Jackson Hole, Wyoming Environmental Restoration Feasibility Report

Feasibility Report and Environmental Assessment

Comment Response Package
Environmental Assessment
Finding of No Significant Impact
Monitoring Plan

**Final
July 2000**

Figure 6-1. All Four Areas - Fish Habitat Unit Projections.

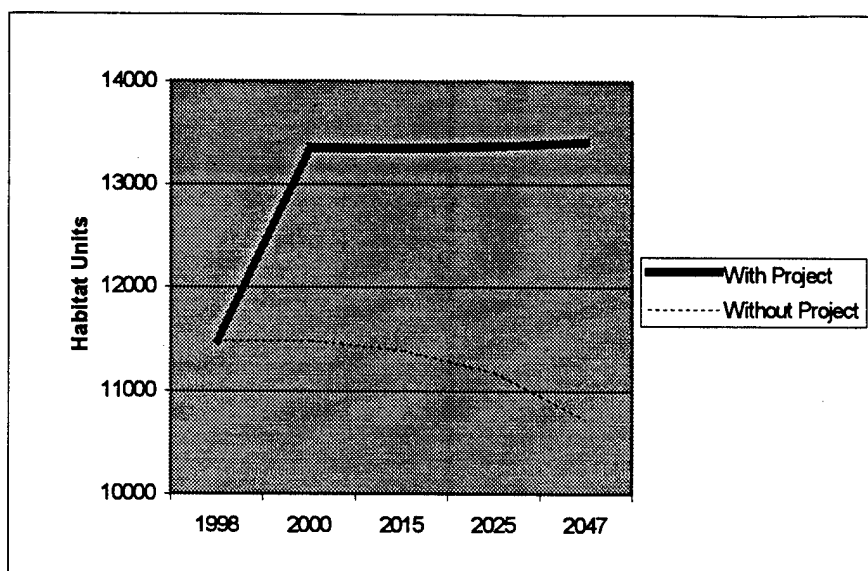
18 6.2.1.1 Cutthroat Trout (Habitat Quantity and Quality Assessment) -- How the assessment of habitat units (with and without project) was determined is unclear. Though the relationships shown in Figure 6-1 may be accurate for a given site, the benefit of this project to the Snake River system as a whole will be negligible and should be noted. Also, unless there is a high level of maintenance on these created habitats, they too will degrade over time.

Comment 18: Figure 6-1 represents a combined estimate of fish habitat unit projections for the four restoration areas and, therefore, is not intended to represent any single site. The Corps recognizes that each site is different and that the quantity and quality of fish habitat that may be restored will vary from site to site. The Corps also recognizes there are numerous areas along the Snake River that could benefit from restoration efforts and that any benefits derived from restoration in the four areas would be a small portion of any overall potential benefits. Monitoring would be used to assess the level of maintenance necessary for the various tools.
